## MONITORING YEAR 3

### MOORES FORK STREAM MITIGATION PROJECT

Wildlands Engineering, Inc. (Wildlands) has reviewed the Division of Mitigation Services (DMS) comments from the Draft Monitoring Year 3 report for the Moores Fork Stream Mitigation Project. The following Wildlands responses to DMS's report comments are noted in italics lettering.

**Table 6a. Visual Stream Morphology Stability Assessment Table**

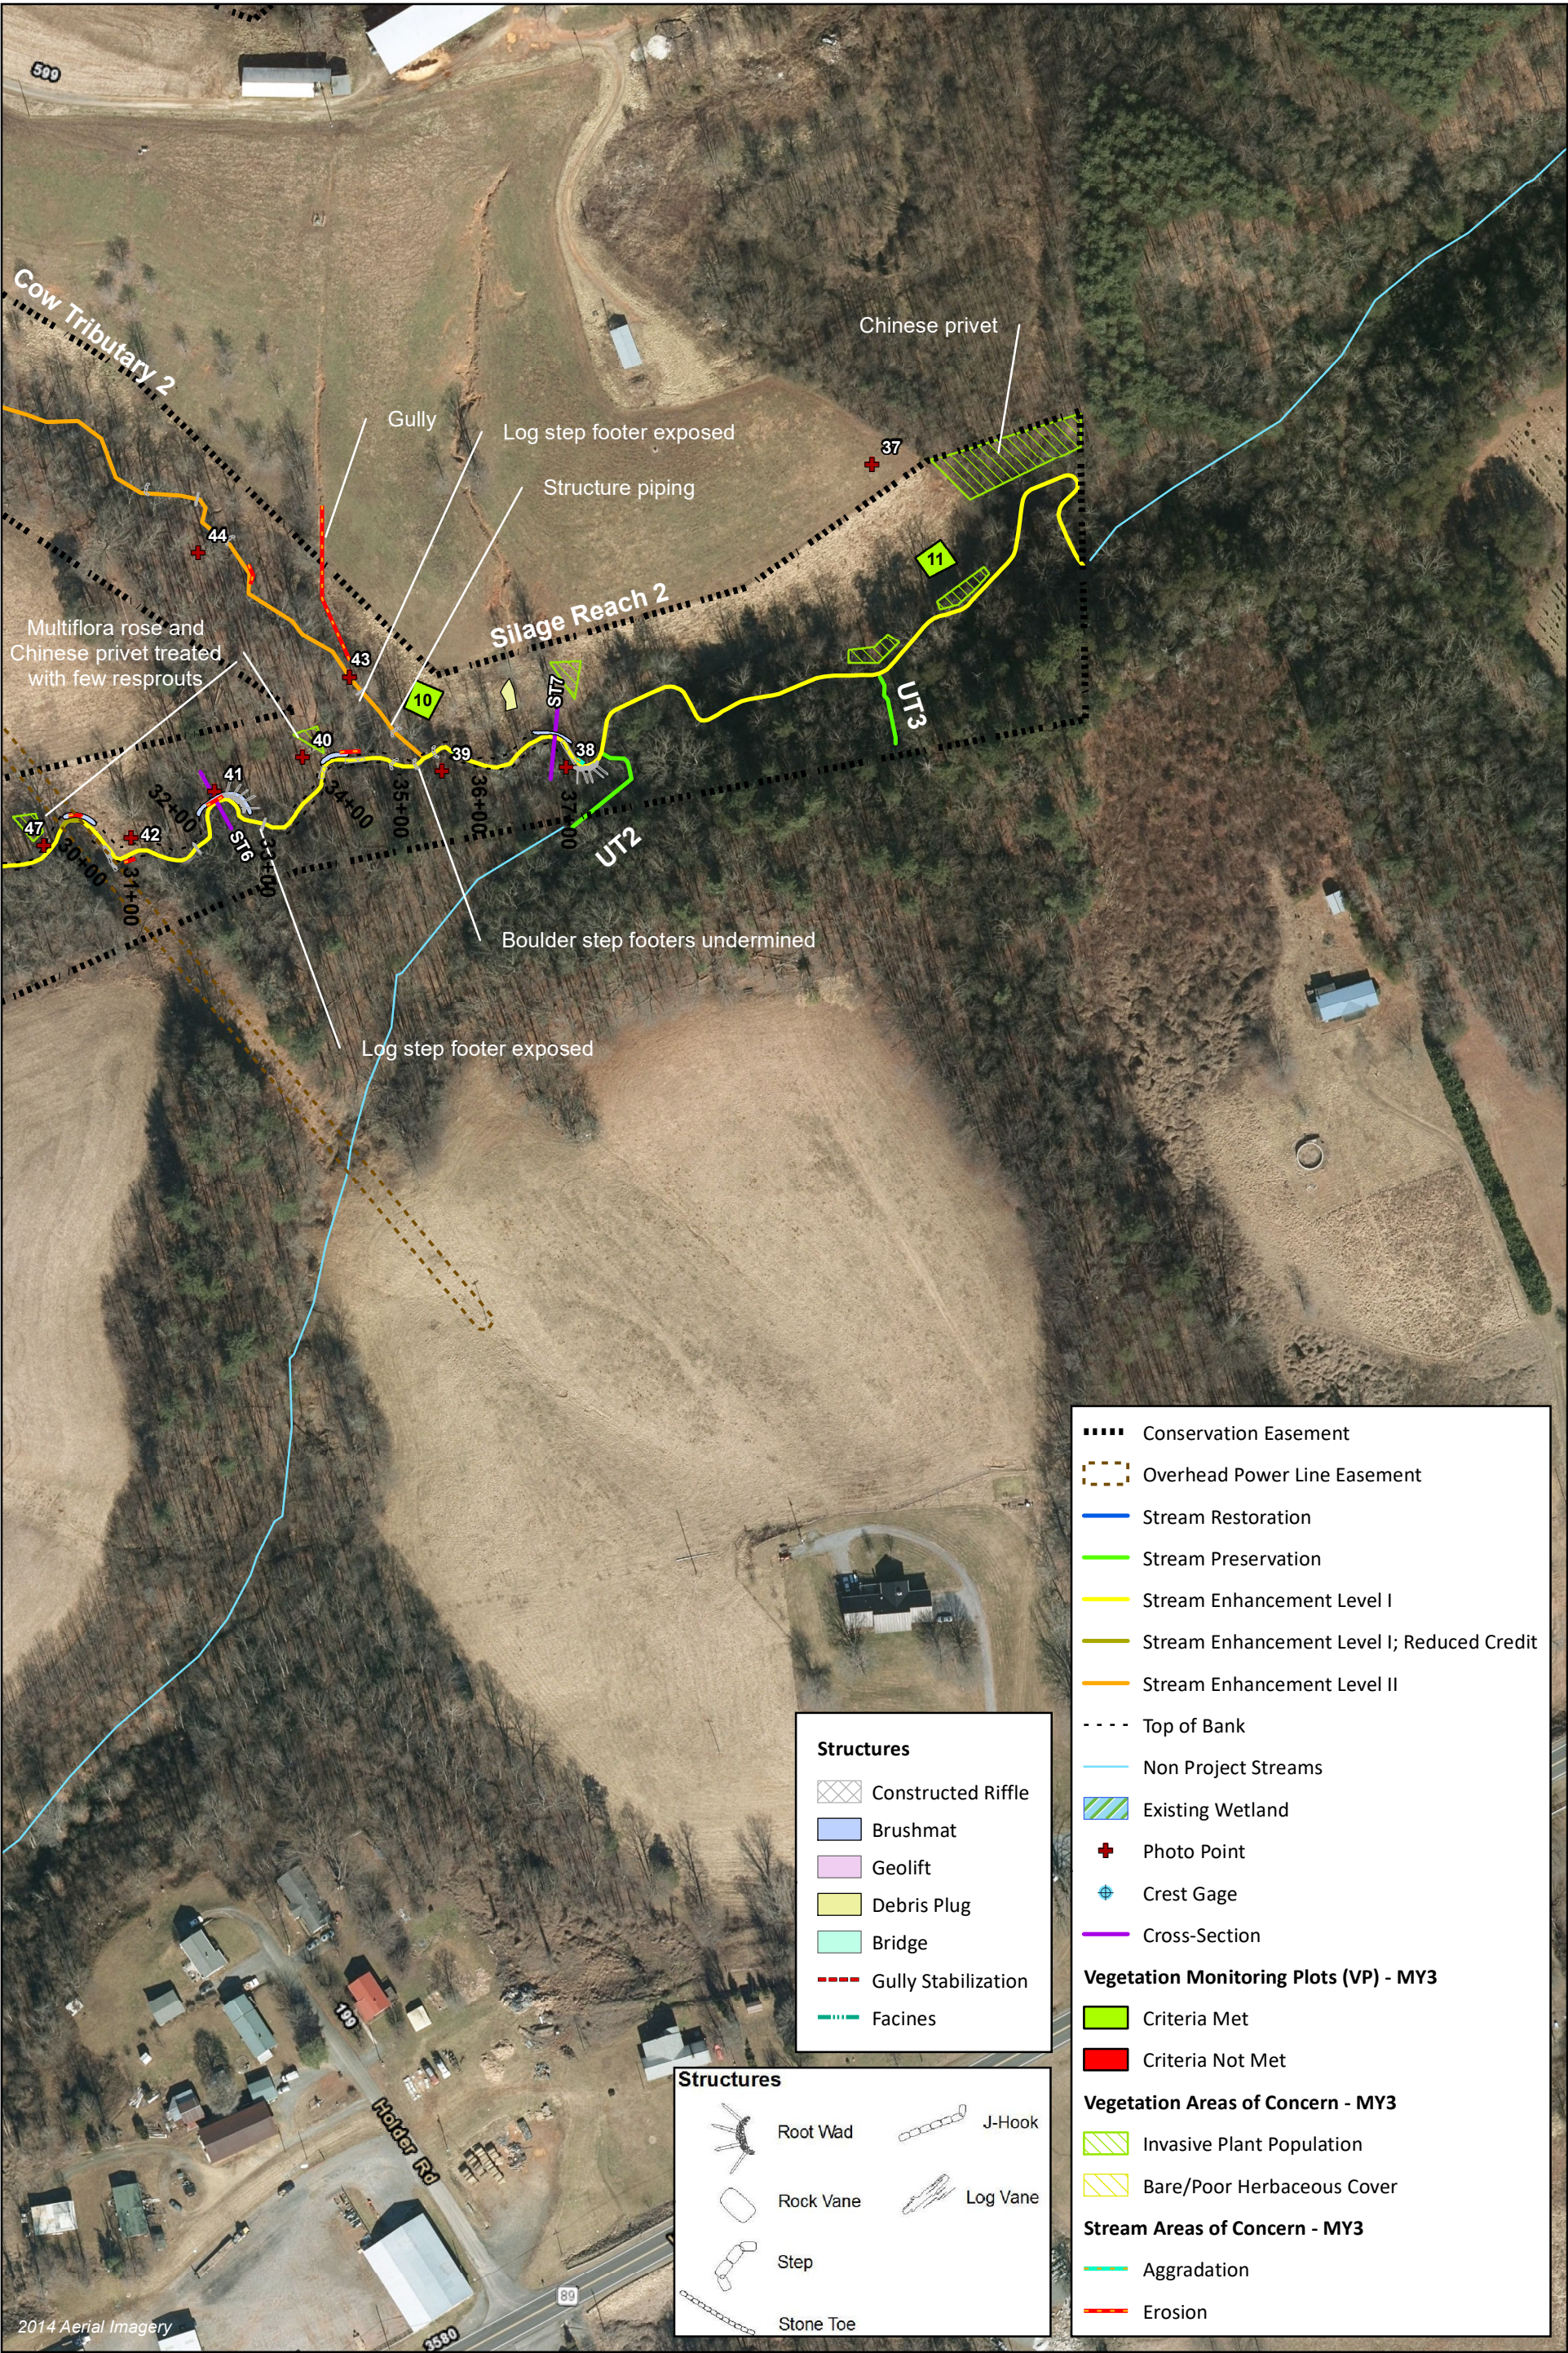
**DMS comment; CCPV: Thanks for providing updated invasive species polygons. Please continue to update as treatment occurs and populations are reduced. This map is a useful tool for the contractor treating the site.**

**DMS comment; CCPV: Please update map with the two additional utility lines.**

**DMS comment; DMS made a site visit on November 26, 2018. We are exploring the possibility of remedial action to some areas depicted on the CCPV as being problem areas. DMS will coordinate with Wildlands when final decisions have been made.**

*Wildlands response; Wildlands will continue to update the CCPV figures as treatment of invasive species occurs and populations are reduced.*

*Wildlands response; The CCPV figures have been updated with the additional utility lines crossing on Moores Fork and Corn Trib.*

*Wildlands response; Thank you for this information. Wildlands will look for communication from DMS about possible remedial action to some areas of concern depicted on the CCPV.*
